City of Fredericksburg

Historic Review Board Meeting Agenda
Tuesday, April 8, 2025 ~ 5:30 PM
New City Hall at East Campus
2818 E. U.S. Hwy. 290
Fredericksburg, Texas 78624

**HISTORIC REVIEW BOARD
MEETING MINUTES
March 11, 2025
5:30 PM**

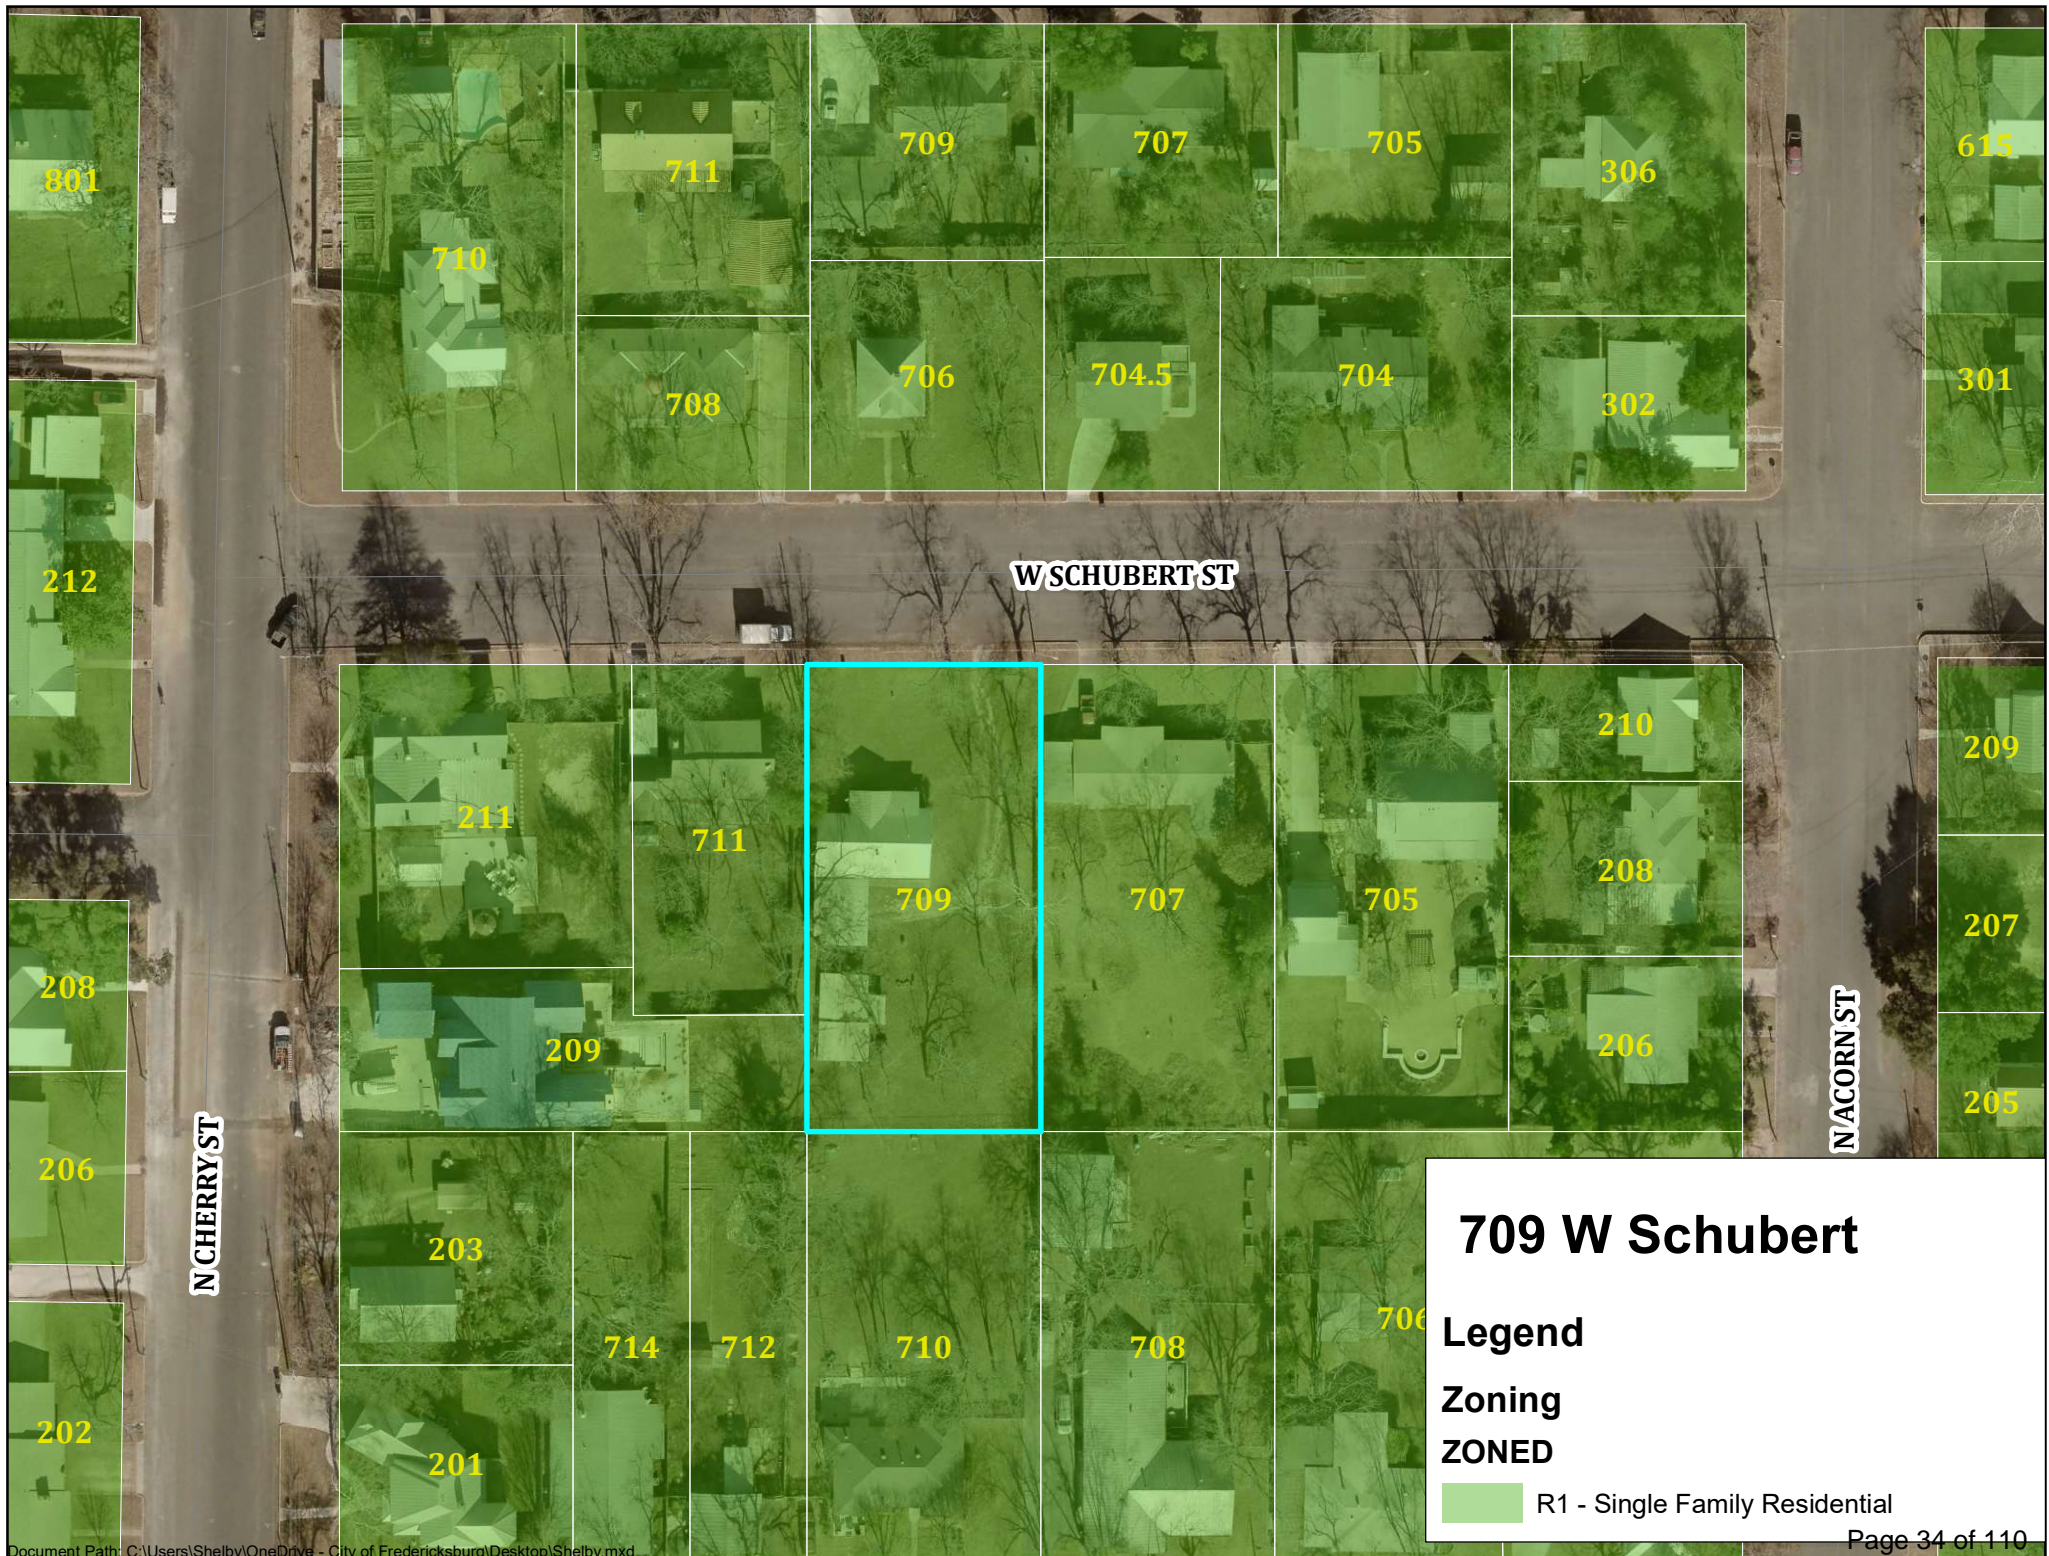
STAFF RECOMMENDATION: The development as proposed is not consistent with historic development patterns 3.4.1(b)(c). The layout places the garage as a focal point, extending 60+ ft back into the lot where it connects with the north-facing wall that serves as the front facade. The 60+ ft long garage combined with the 25 ft front set back results in a residence that is not accessible for the first 85 of the lot. Neighboring properties in the same block have an average of a 25 ft setback to the front entry/front porch.

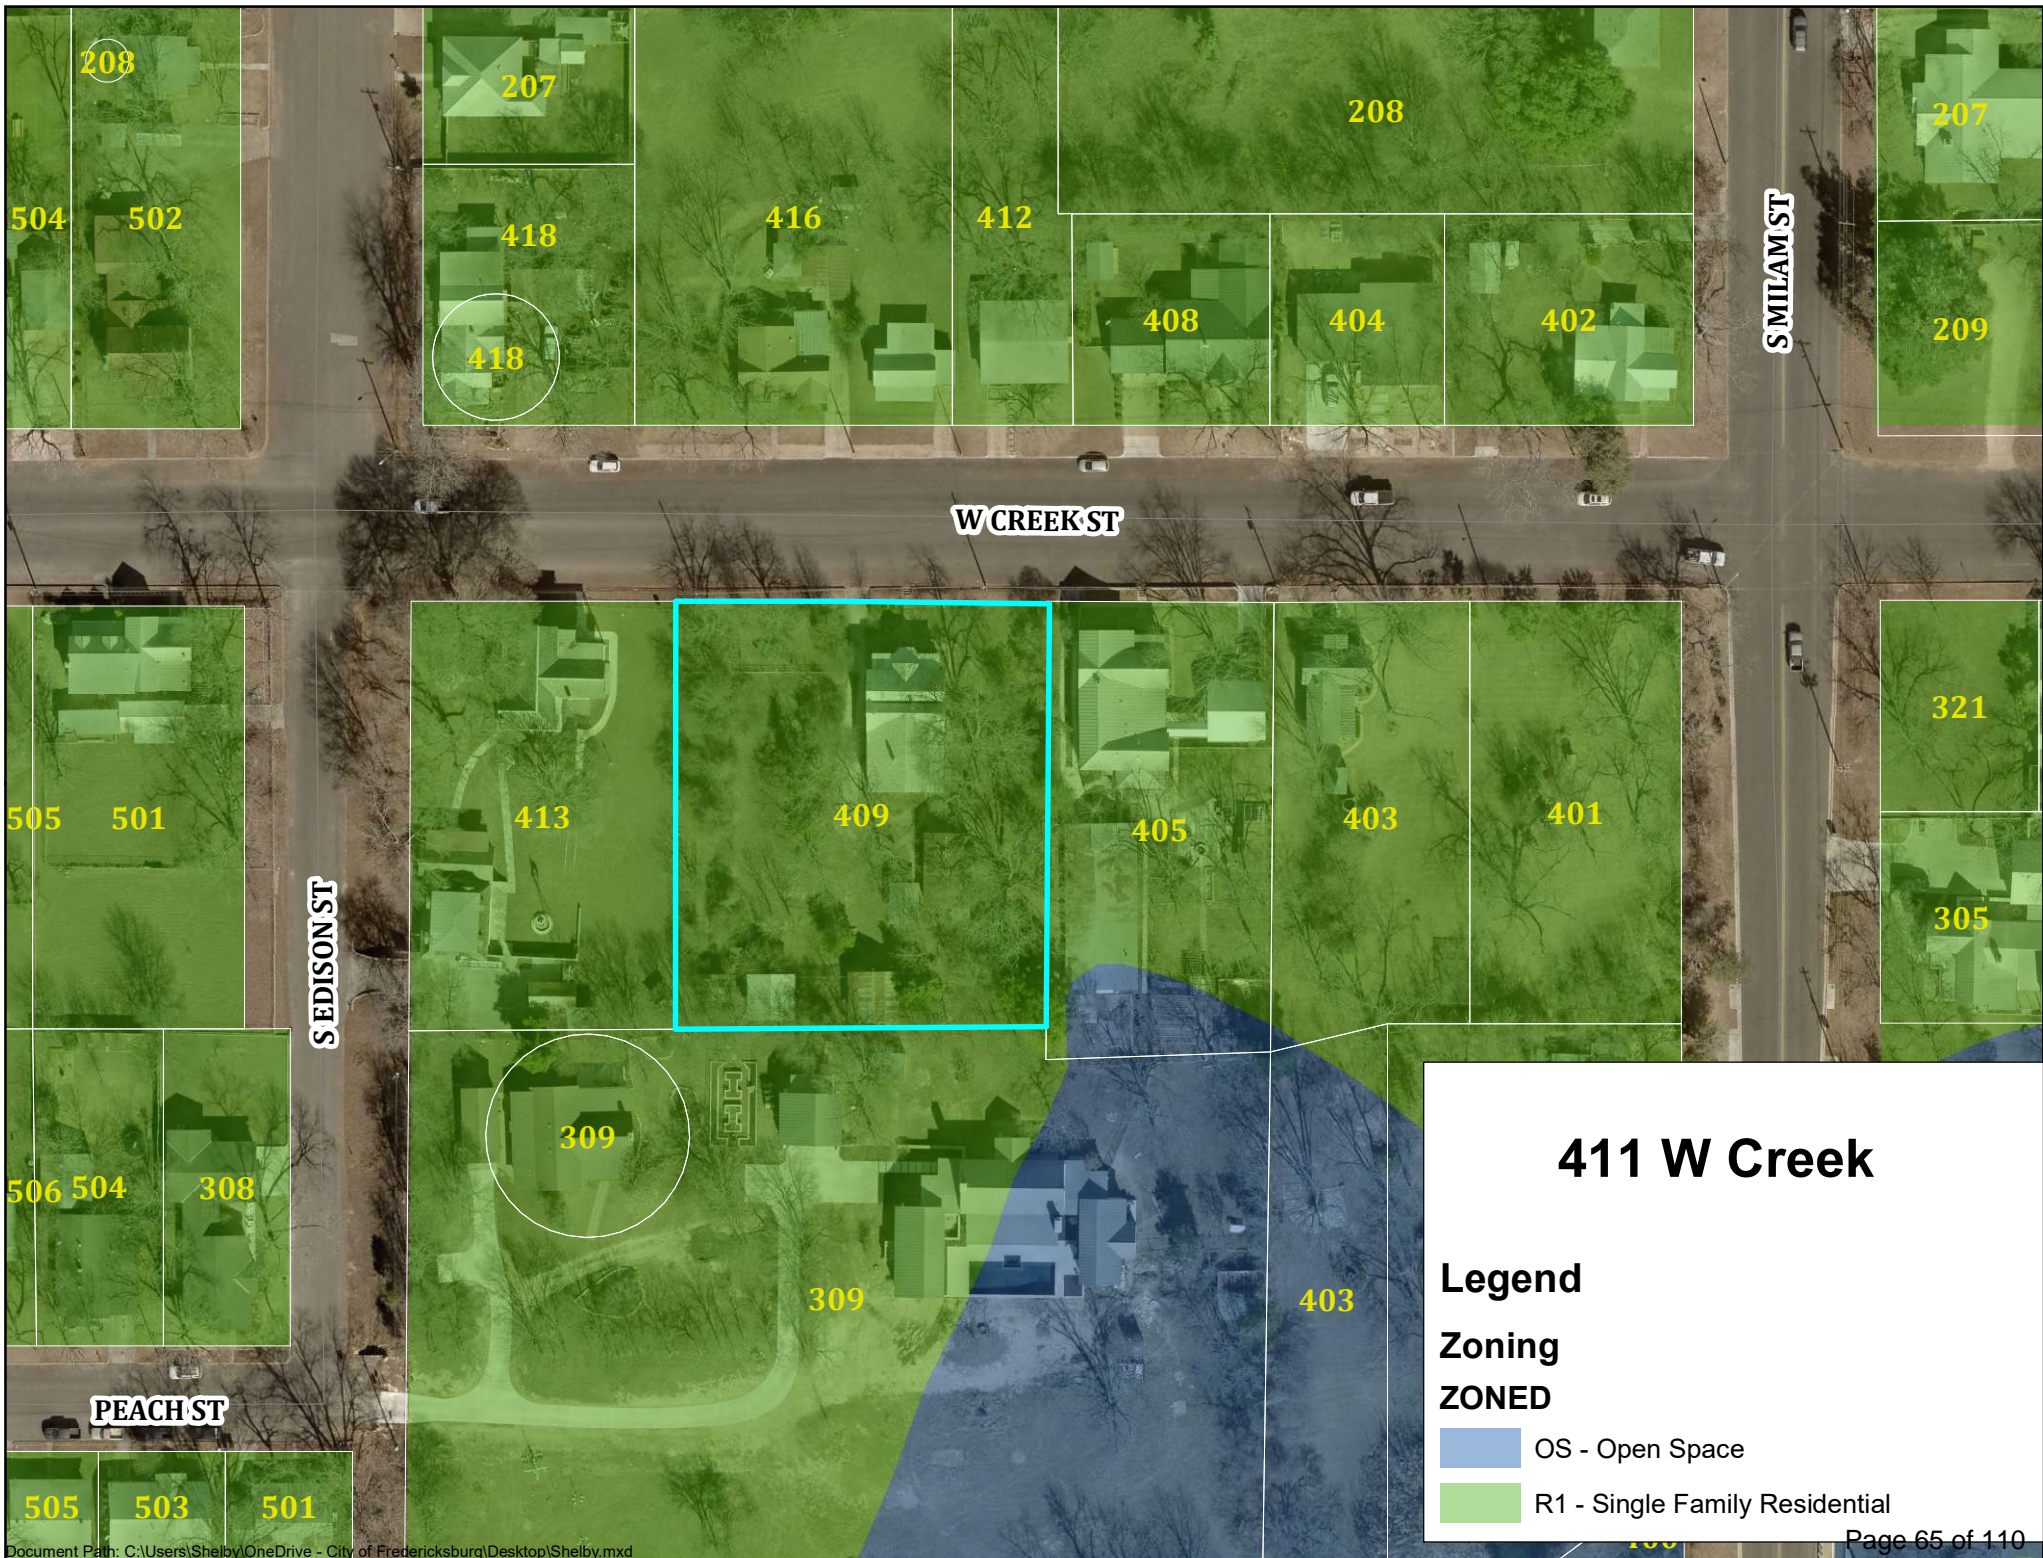
The overall development is consistent with historic development patterns 3.4.1(c), which places the residence at the front of the lot and an accessory building at the rear. The applicant also took feedback from the Board and made changes to the front facade, such as incorporating the stone veneer into one wall, adding another gable into the roof line and making modifications to the front porch.

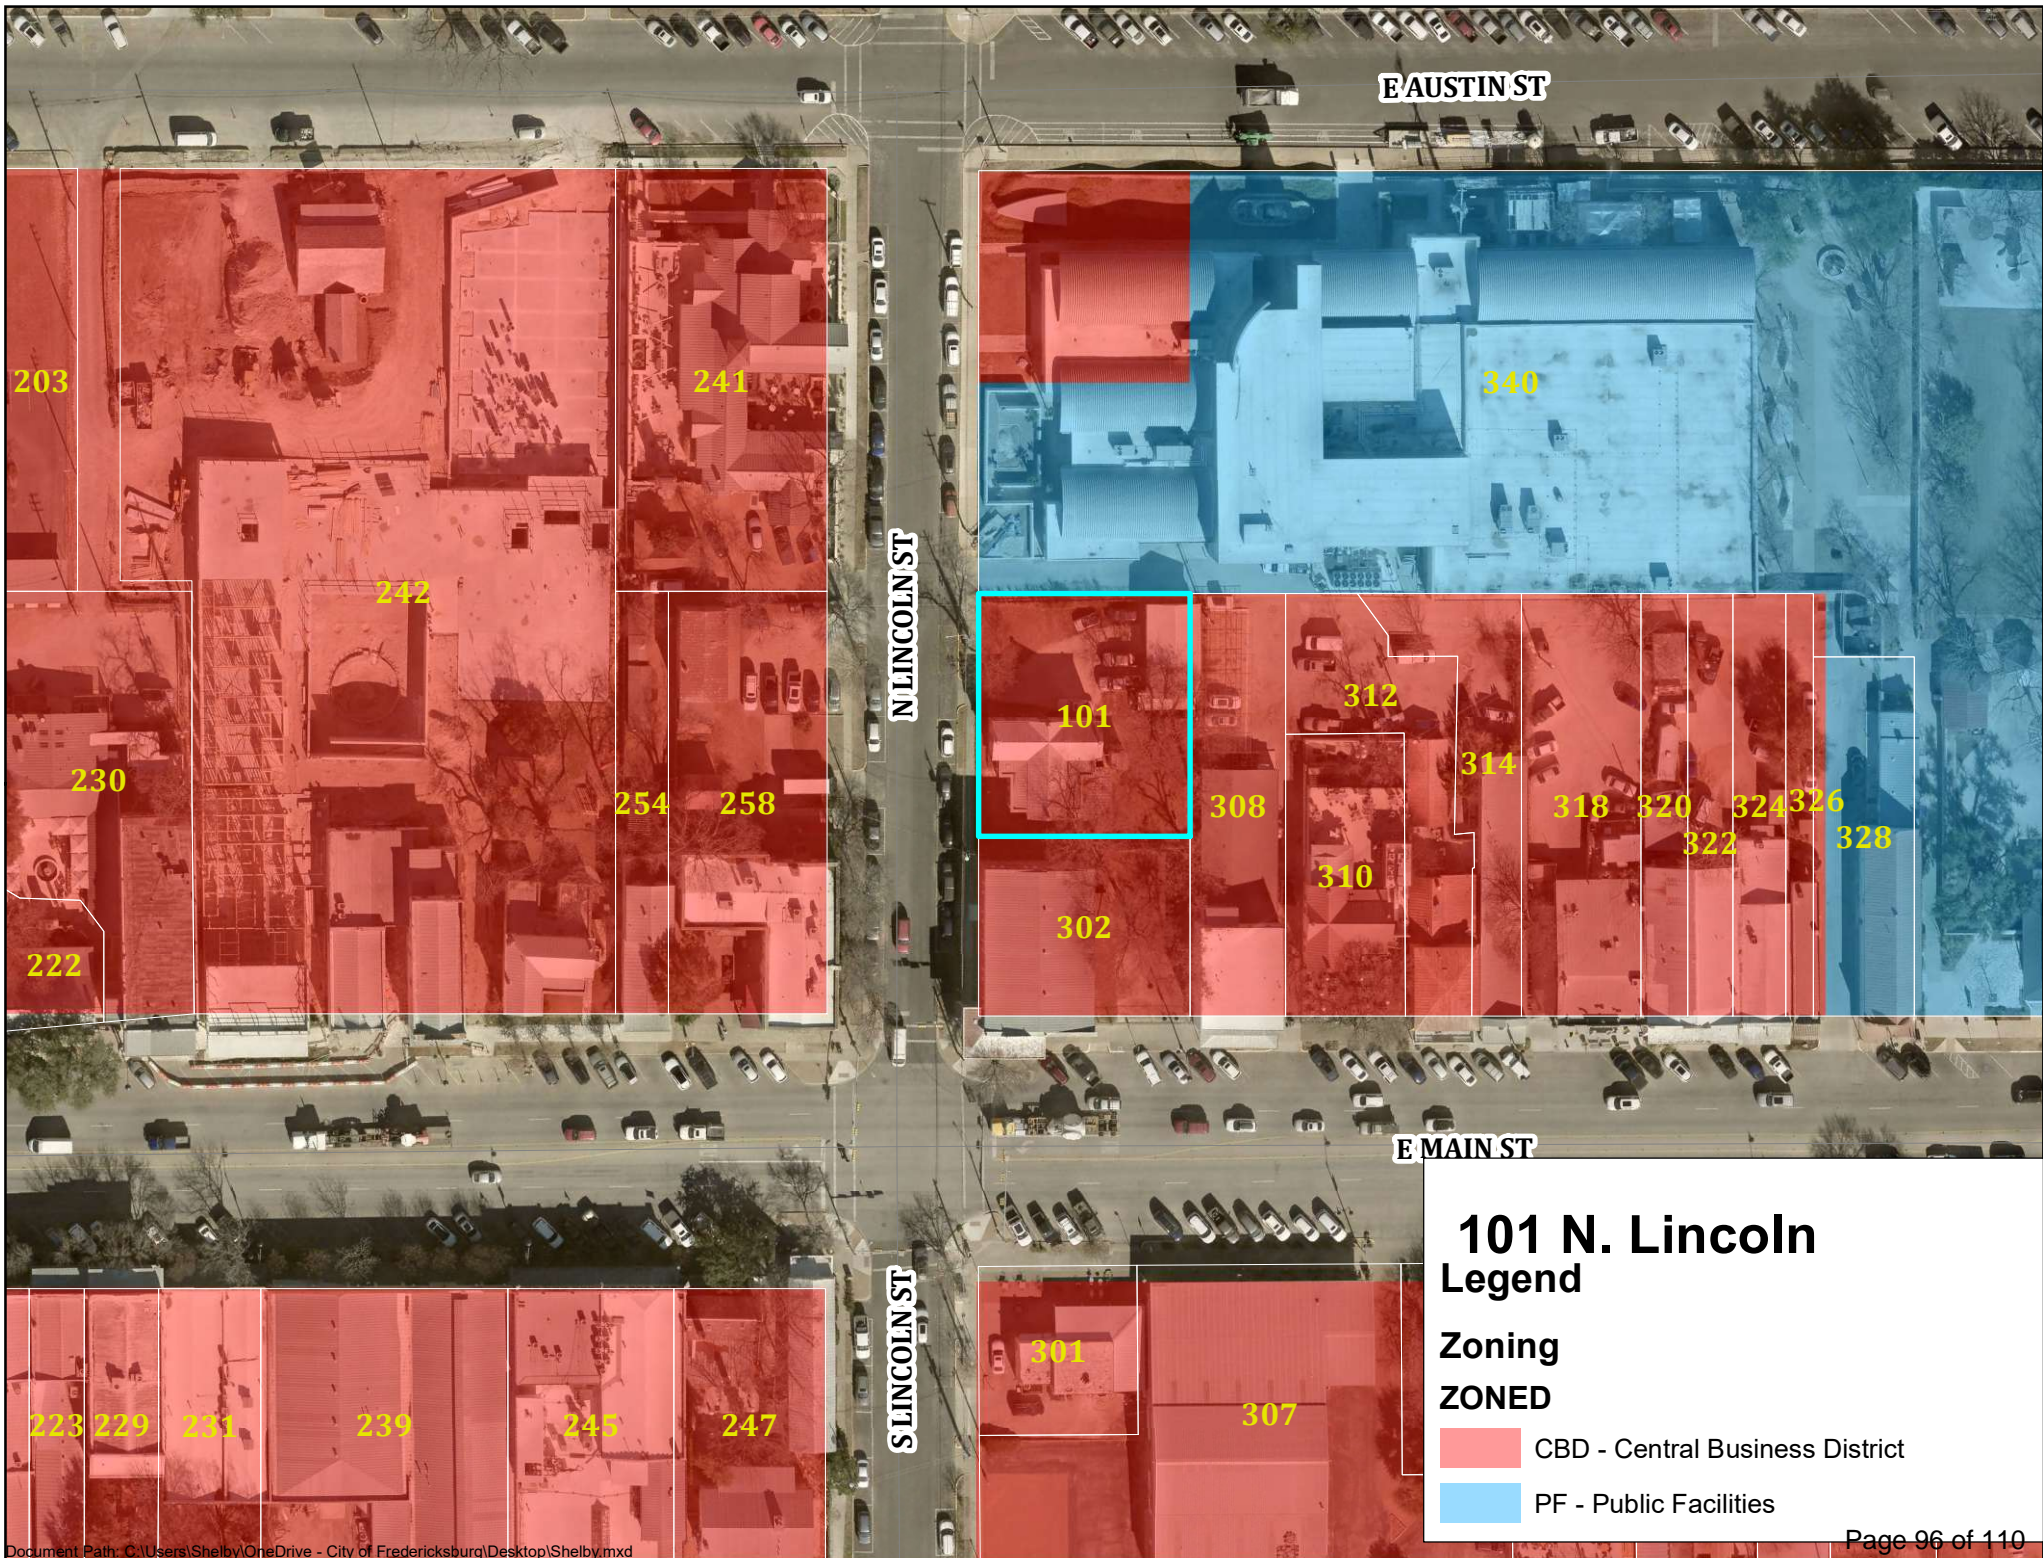
The property is a High-rated resource used as an example of appropriate porch details in Sec. 3.2.5 of the Historic Design Guidelines and Standards (figure 3-16). Staff does not recommend approval of the changes to the porch details such as the changes to the trim which include, longhorns and crosses. This recommendation is in keeping with Sec. 3.2.5(b)(c).

Porch Details as of 04/01/2025

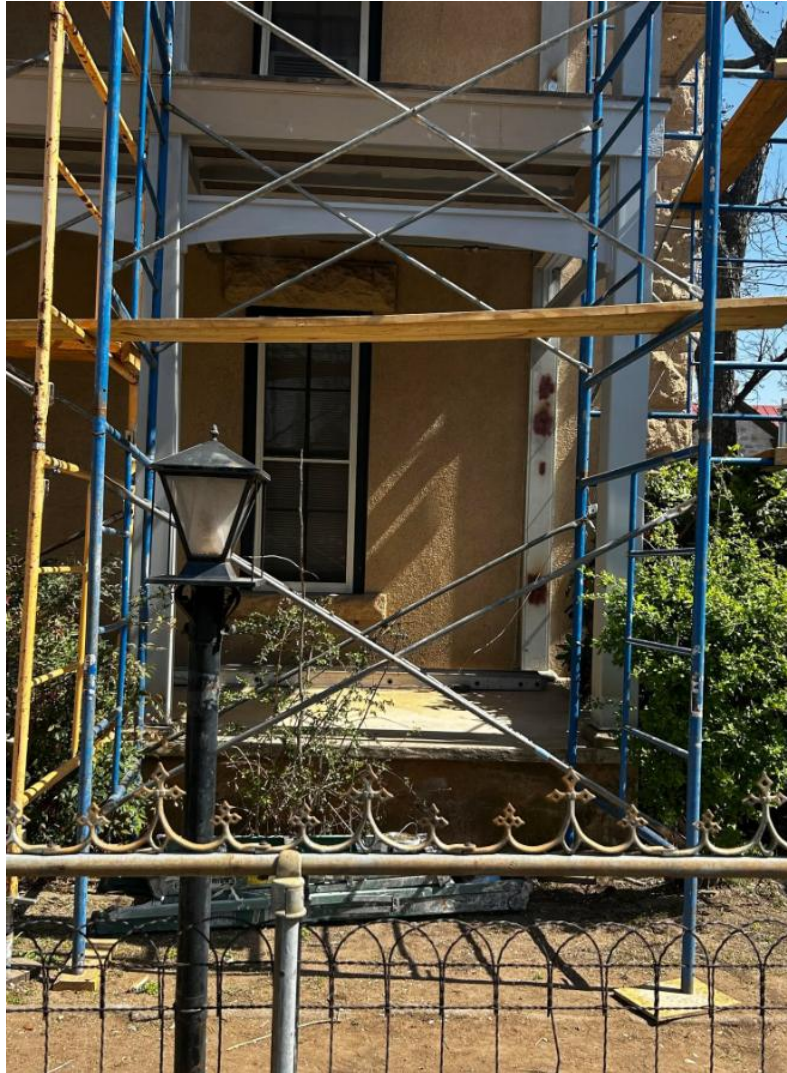
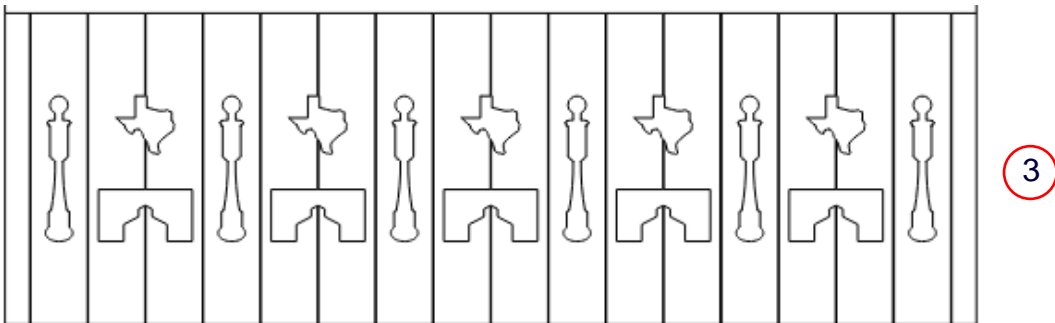
Ultimately, the applicant is requesting permission for work that has already commenced, including a change to the porch details, such as new designs in the trim and a heavier porch post. The applicant

My recommendation for the mentioned project is a HSS 8x8x1/4" column for the porch posts. I am recommending the steel column for two reasons. The first reason is longevity and rot resistance. The second reason is due to the project having an upper exterior deck. The configuration of an exterior upper deck with roof support is a potentially dangerous situation when you have weathering of a wood porch column over time. The base of the post usually rots with time and weather allowing the structure to become unstable. If you have any other questions or concerns, please feel free to contact me.
